**DEMOLITION BID FOR LUNT REDEVELOPMENT PROJECT,
GREENFIELD, MA 01301 (Parcel 95-1, UTB)**

**DEMOLITION BID FOR LUNT REDEVELOPMENT PROJECT, GREENFIELD, MA
01301 (Parcel 95-1, UTB)
Addendum #3 – September 16, 2015**

PHOTO A

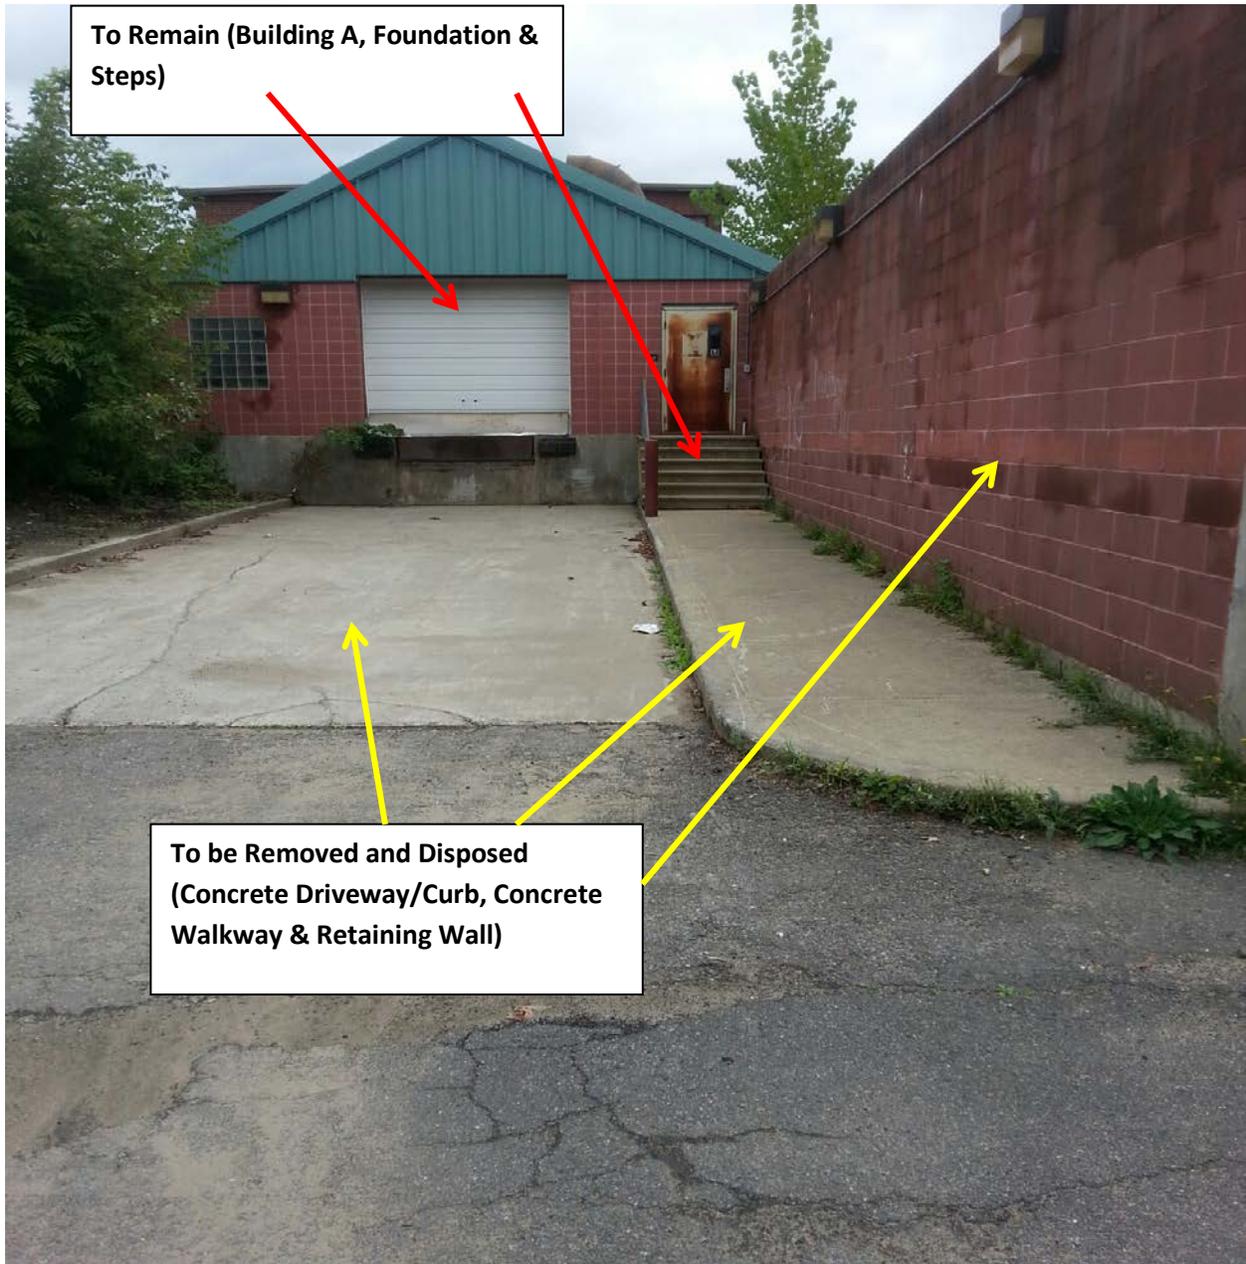
- Item A:** **Building A on Marked up Demo Plan:** Building A on the marked up demo plan is to remain and not be demolished under the Contract. However, the block retaining wall connecting to Building A, the sidewalk leading to the stairs of Building A, and the concrete driveway leading to the loading doors of Building A shall be demolished and disposed of under the Contract. *See attached Photo A.*

PHOTO B

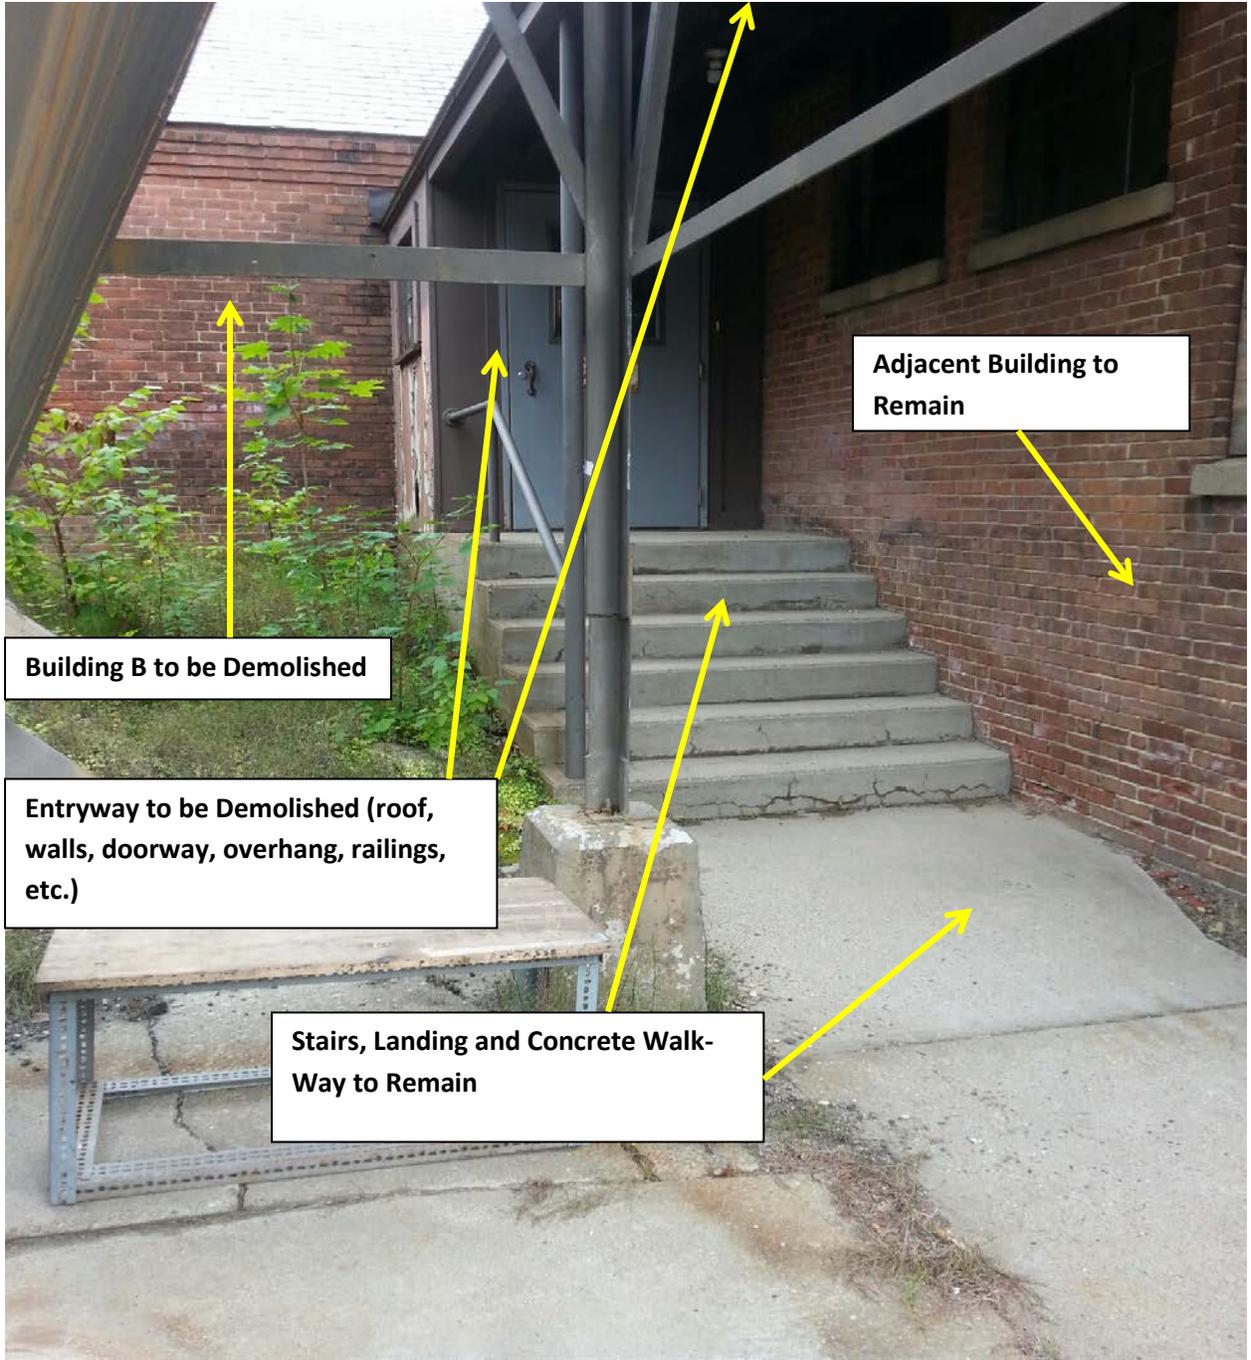
- Item B:** **Building A to Remain:** Prior to the start of the work, the Developer for the site shall provide structural supports to the existing roof section between Building A and Building B. The Developer shall also saw-cut the concrete slab to allow the concrete floor section abutting Building B to be removed and disposed of as part of the demolition. Additionally, the CMU walls and roof sections within this slab area shall also be demolished and disposed. *See Attached Photo B.*

Building B to be Demolished
Includes Concrete Slab and
CMU Walls to Allow
Separation

Building A to Remain

**Owner to Provide
Structural Supports at
Roof & Saw-Cut Floor**
